Meeting Agenda Plat Committee

Monday, May 10, 2021

1. [KPB-3115](#) Christensen Tracts 2021 Addition
KPB File 2021-046
Geovera, LLC / Hough
Location: East End Road & Hough Road
City of Homer

KPB 2021-046

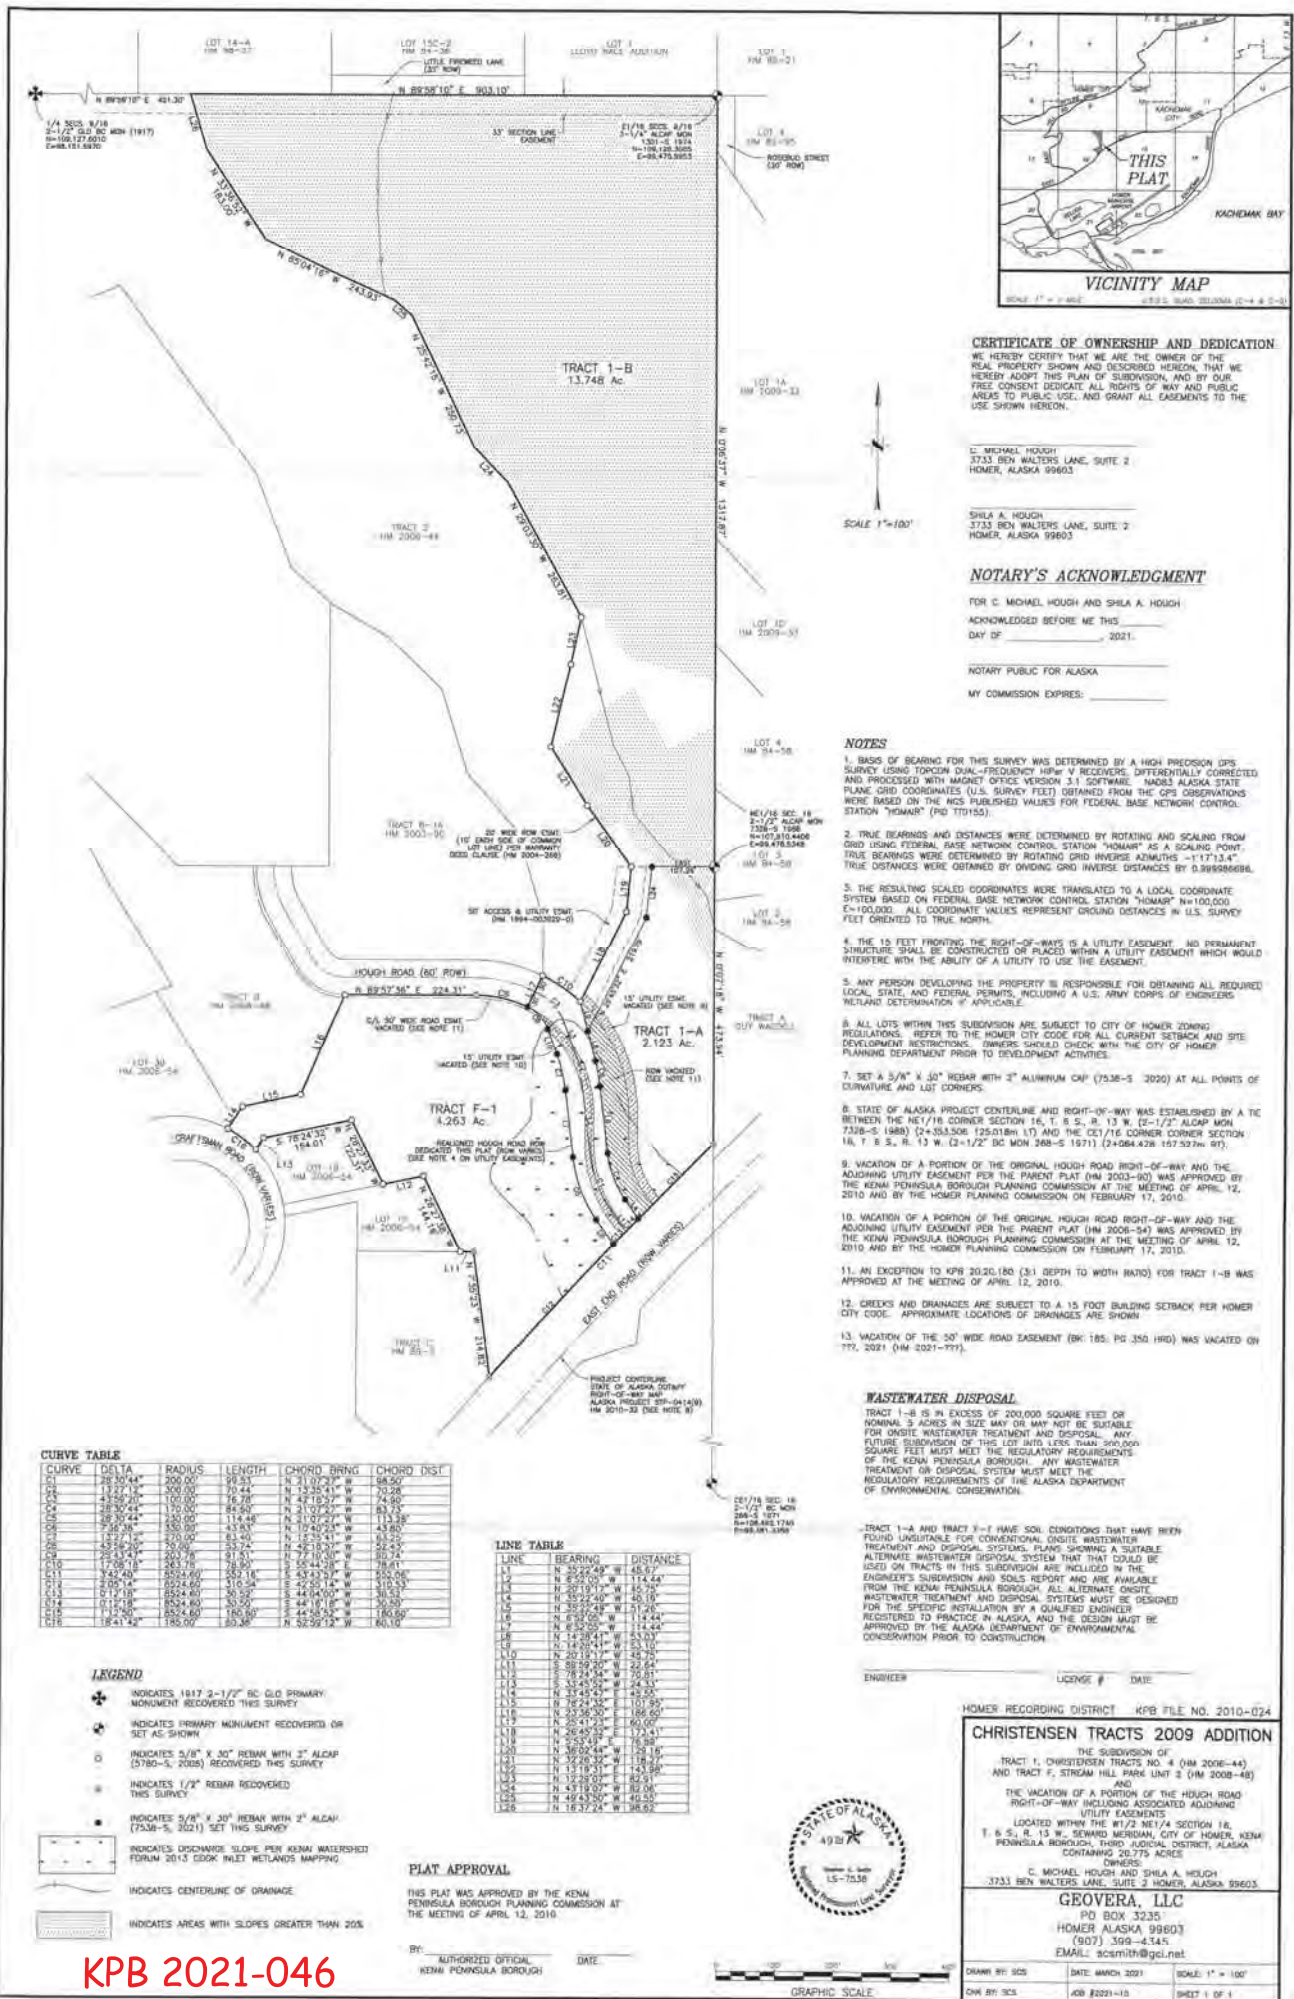
- C. The location, width, and name of existing or platted streets and public ways, railroad rights-of-way, and other important features such as section lines or political subdivisions or municipal corporation boundaries abutting the subdivision;
Platting Staff Comments: DOT commented that the ROW for East End Road is as platted and referred to DOT ROW mapping 0414(10), sheet 37, dated 2016. Staff would like to have a plat note or a label within the ROW depiction referring to the DOT map. Reference should include "Per DOT Record of Survey Alaska Project 0414(10), sheet 37, HM 2016-3."
Staff recommendation: Add by plat note or label the information for East End Road.

State Department of Transportation Comments: The ROW for East End Road is as platted, see also DOT ROW Mapping 0414(10), sheet 38, dated 2016.

KPB 2021-056

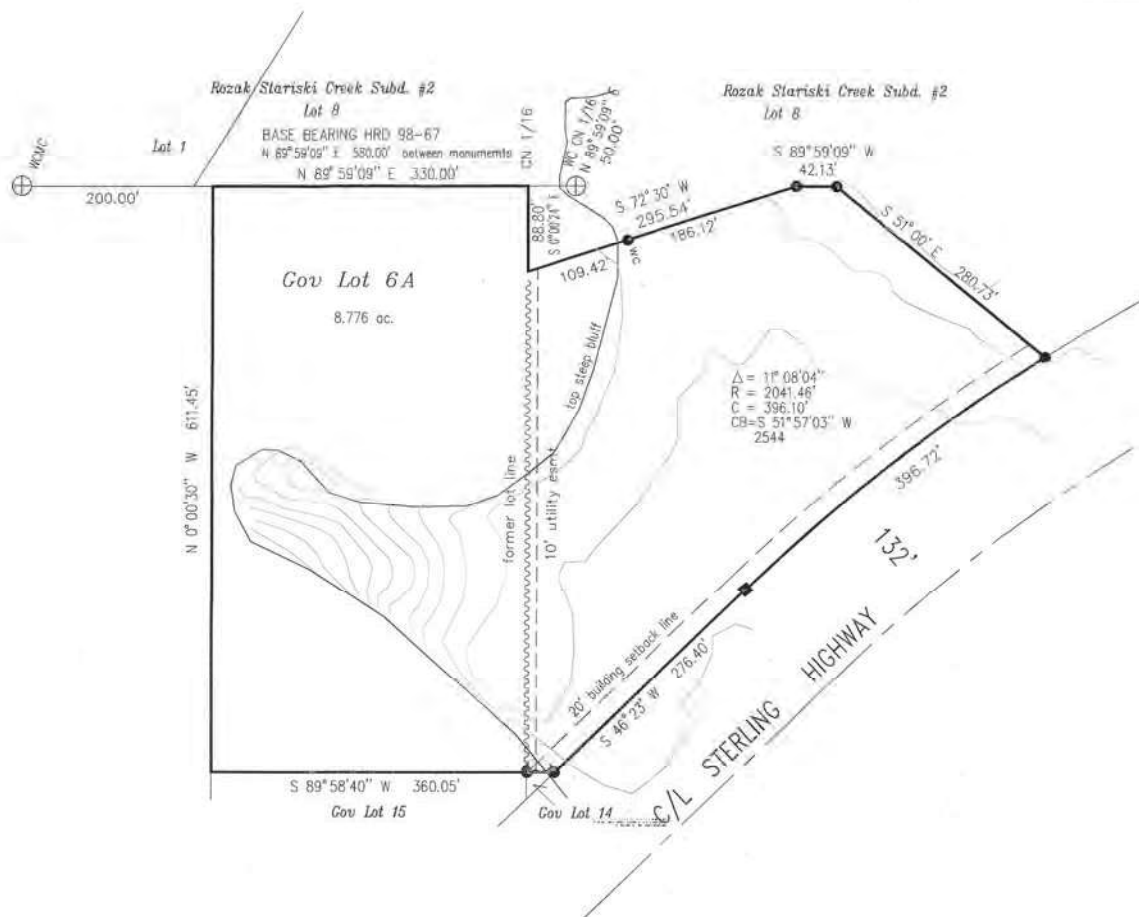
KPB Roads Dept. comments	Within KPB jurisdiction, no comments.
SOA DOT comments	The ROW for the Sterling Highway is as shown on sheet 23 of 38, F-021-1(2), Homer Serial Number 63-423

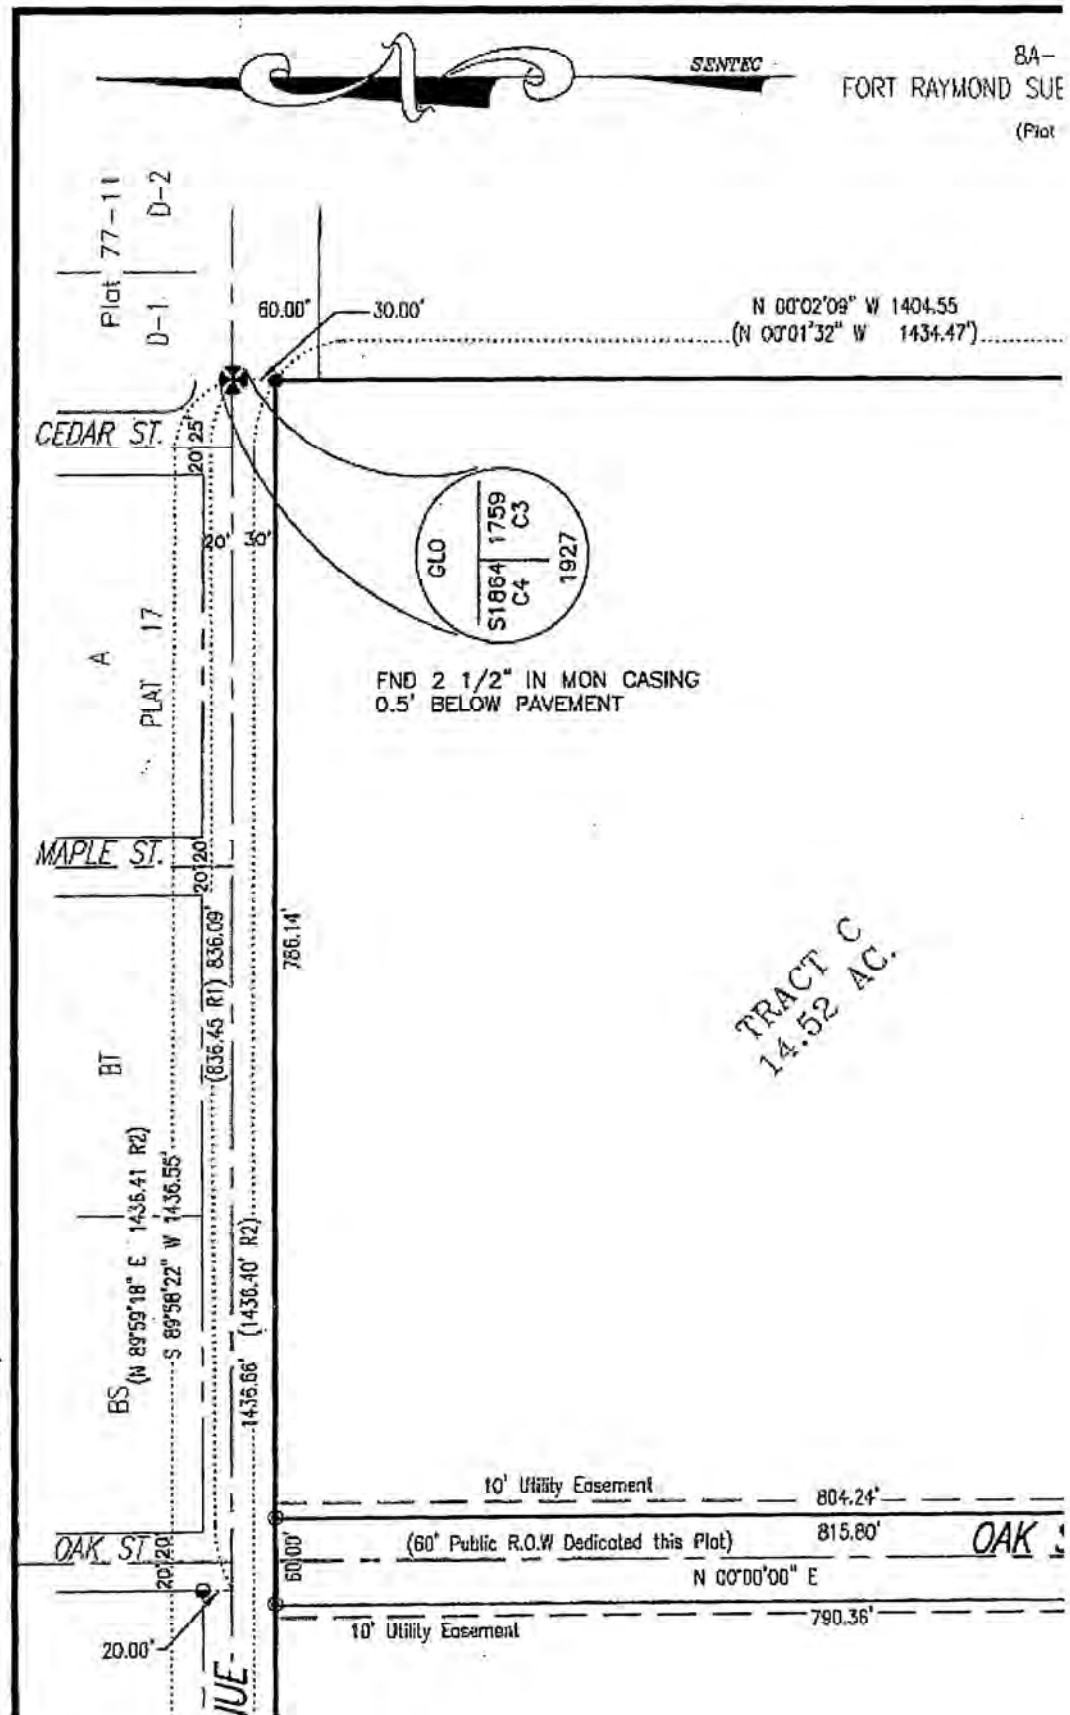
The plat for my property shows that 30' of ROW has already been granted from Tract B and C. The half right-of-way on the north side of this ROW is twenty feet wide.

For the record, I feel it would not be fair to require that I be required to grant more ROW when I subdivide either Tract B or Tract C in the future.

Hemlock Avenue ROW should be the full 60' to accommodate future needs for traffic, sidewalks, utilities, etc. The 2030 Seward Comprehensive Plan Update, Volume II-15 Section 6, Land Use on page 23 states: "Plan right of way acquisitions to develop Hemlock Avenue to the Seward Highway."

Now is the right time to ensure that a full 30' ROW is provided on the north half of the ROW in accordance with the KPB Subdivision Ordinance.
